OMAHA PUBLIC POWER DISTRICT
FORT CALHOUN STATION
UNIT No. 1

ATTACHMENT A

FORT CALHOUN
TECHNICAL
SPECIFICATIONS

ATTACHMENT B

FIGURE
5-1

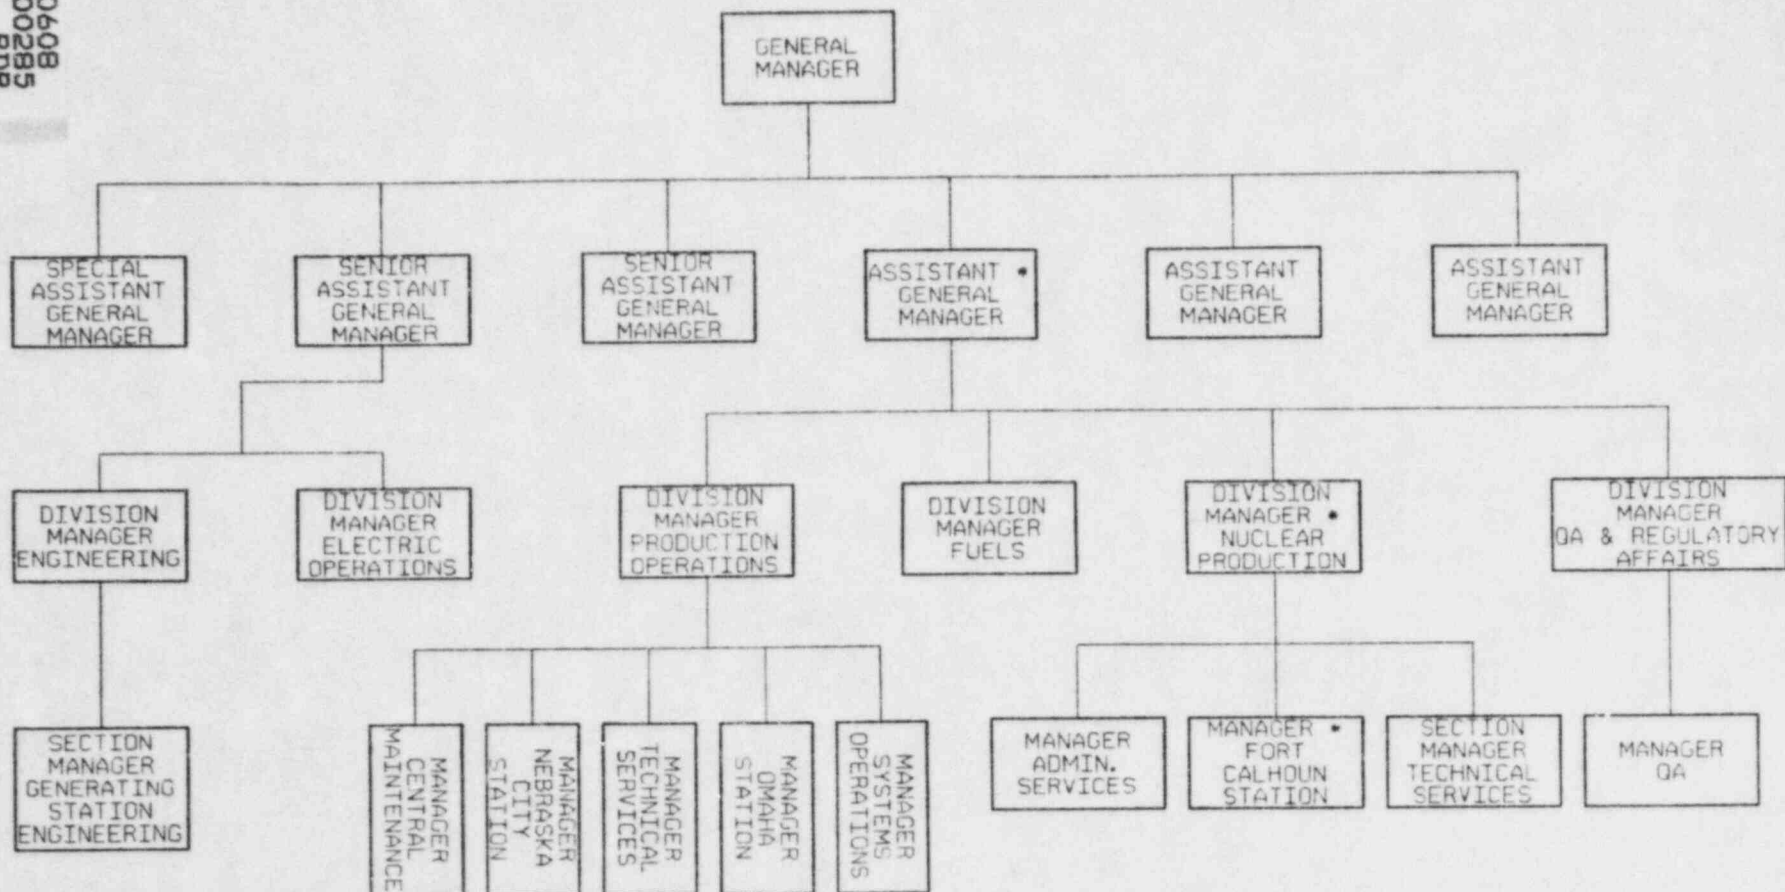
The plant support organizational structure is being revised to reflect licensee reorganization. A separate nuclear division has been designated within the licensee's organization. This new division provides dedicated management support to the Fort Calhoun Station. Previously, the Division Manager - Production Operations and the Section Manager - Operations had direct responsibility for all electrical generating facilities owned and operated by the Omaha Public Power District, including fossil-fueled generating units. Under the revised plant support organization, the Section Manager - Operations position has been eliminated, with the Manager - Fort Calhoun Station reporting directly to the newly-designated Division Manager - Nuclear Production. Changes to Section 5.5.1 (subparts 5.5.1.6.e, 5.5.1.7.c, and 5.5.1.8), Section 5.5.2 (subparts 5.5.2.2, 5.5.2.8.h, 5.5.2.9, 5.5.2.10.a, 5.5.2.10.b, and 5.5.2.10.c), Section 5.6.1 (subpart 5.6.1.b), and Section 5.7.1 (subparts 5.7.1.b and 5.7.1.d) are proposed to reflect the Division Manager - Nuclear Production position and to reflect a title change for the Assistant General Manager, to whom the Division Manager - Nuclear Production directly reports.

FIGURE
5-2

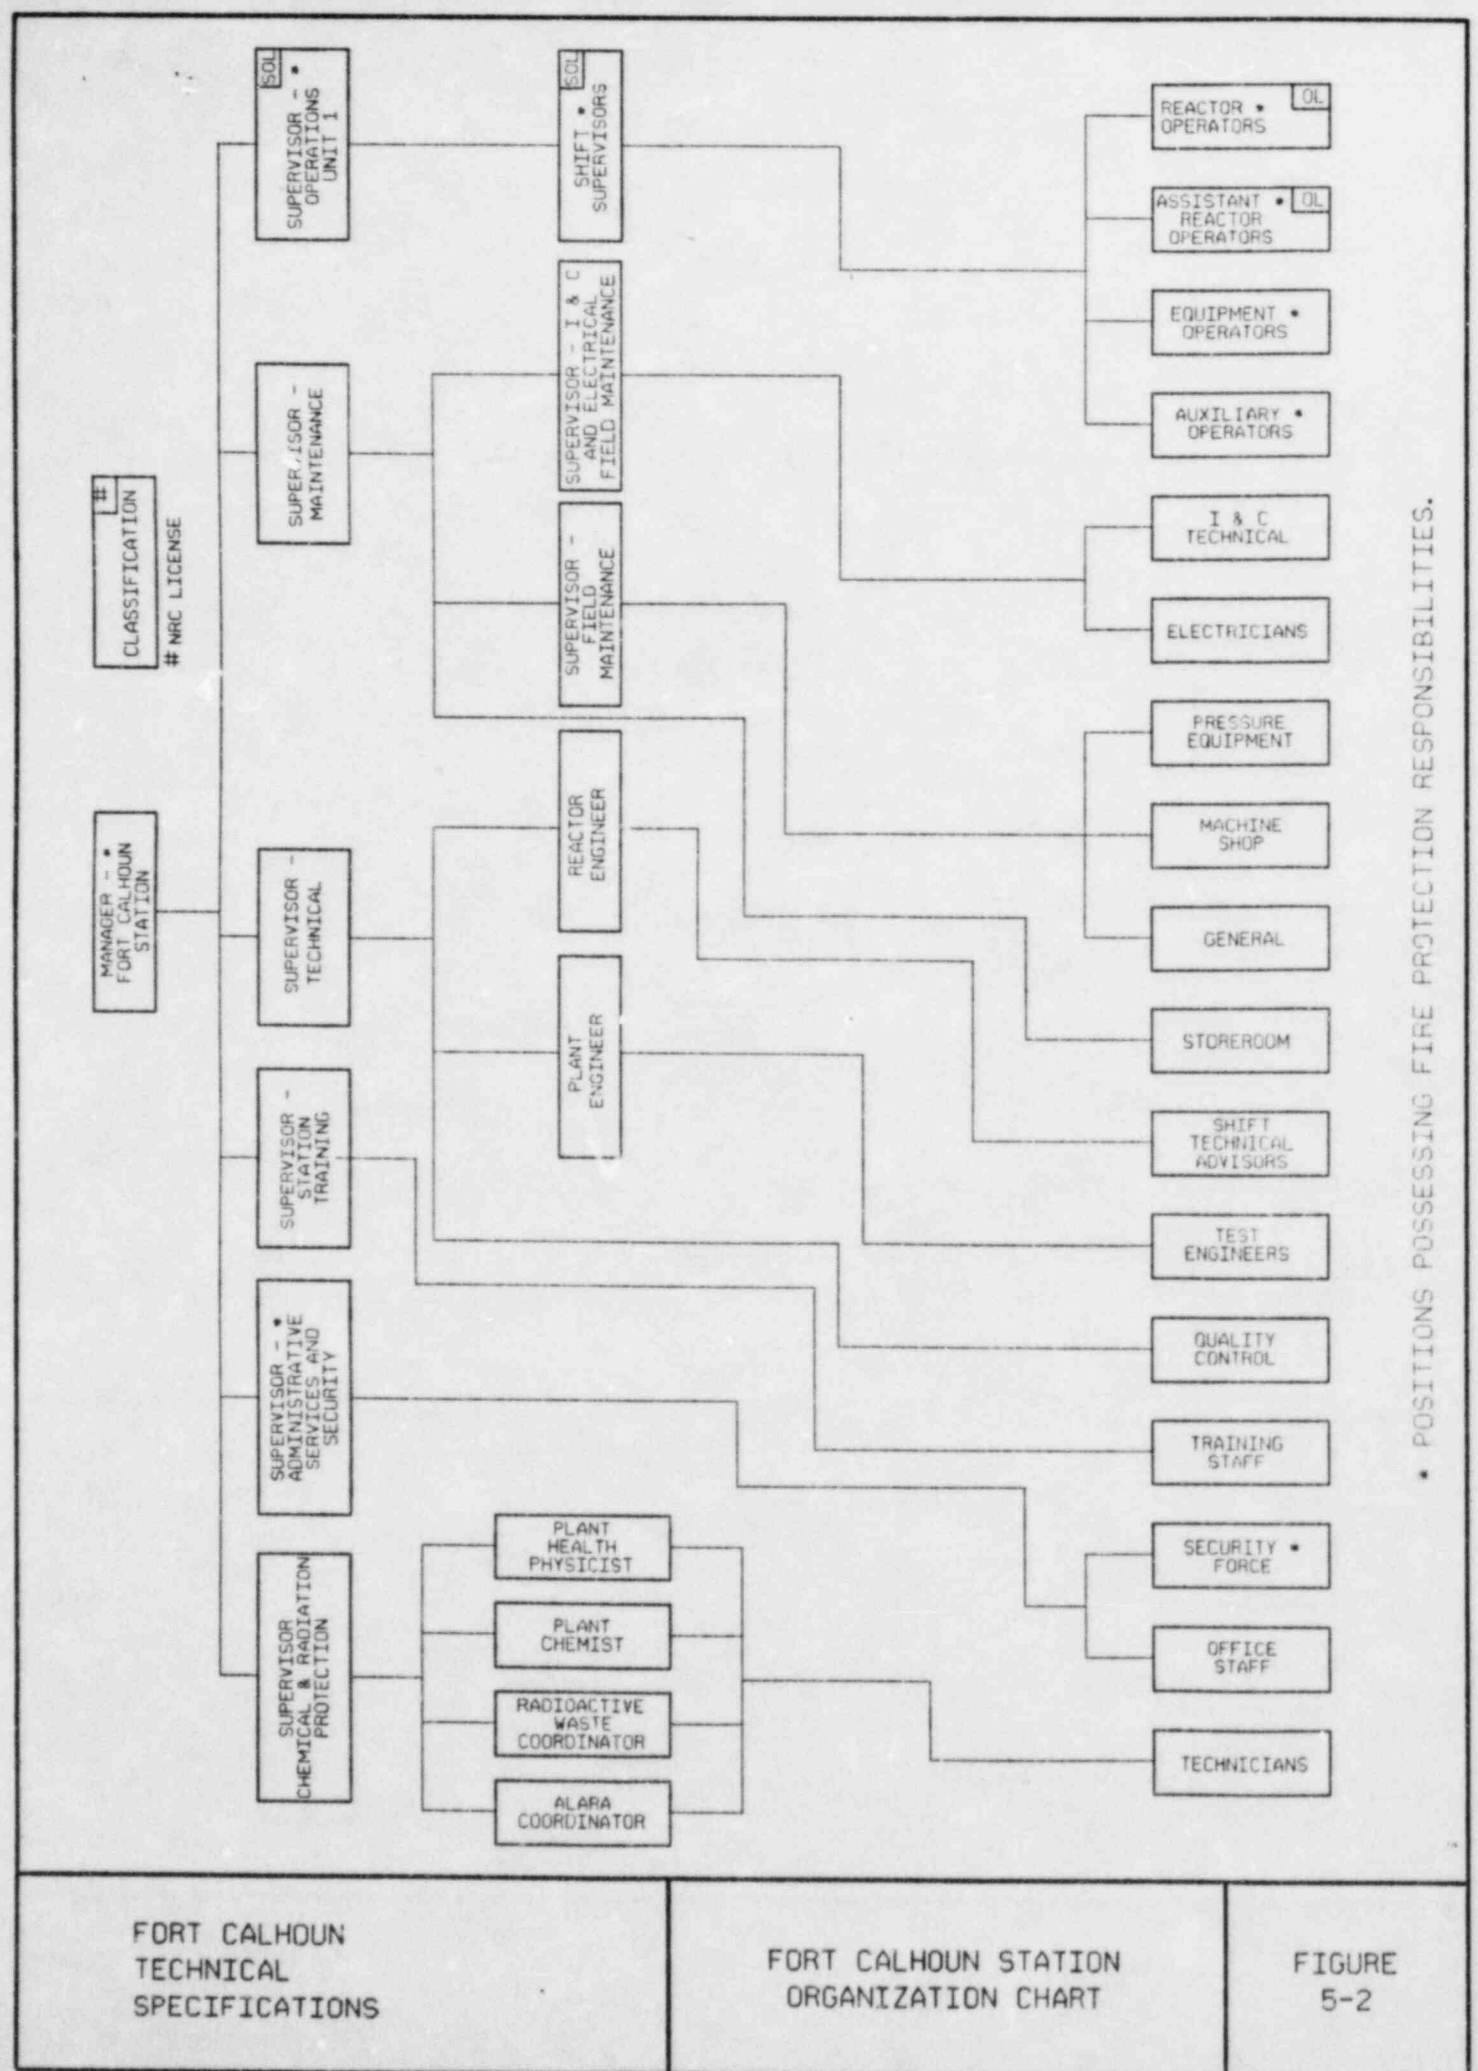
The plant organization has been changed to reflect three new positions: the ALARA and RAD Waste Coordinators and the Supervisor - Station Training. The Supervisor - Station Training reports directly to the Manager - Fort Calhoun Station and will be responsible for plant staff training as indicated in the proposed change to Section 5.4.1. These changes are also reflected on Figure 5-2, "Fort Calhoun Station Organization Chart." Additionally, this figure has been corrected to provide the correct title of "Supervisor - Administrative Services and Security".
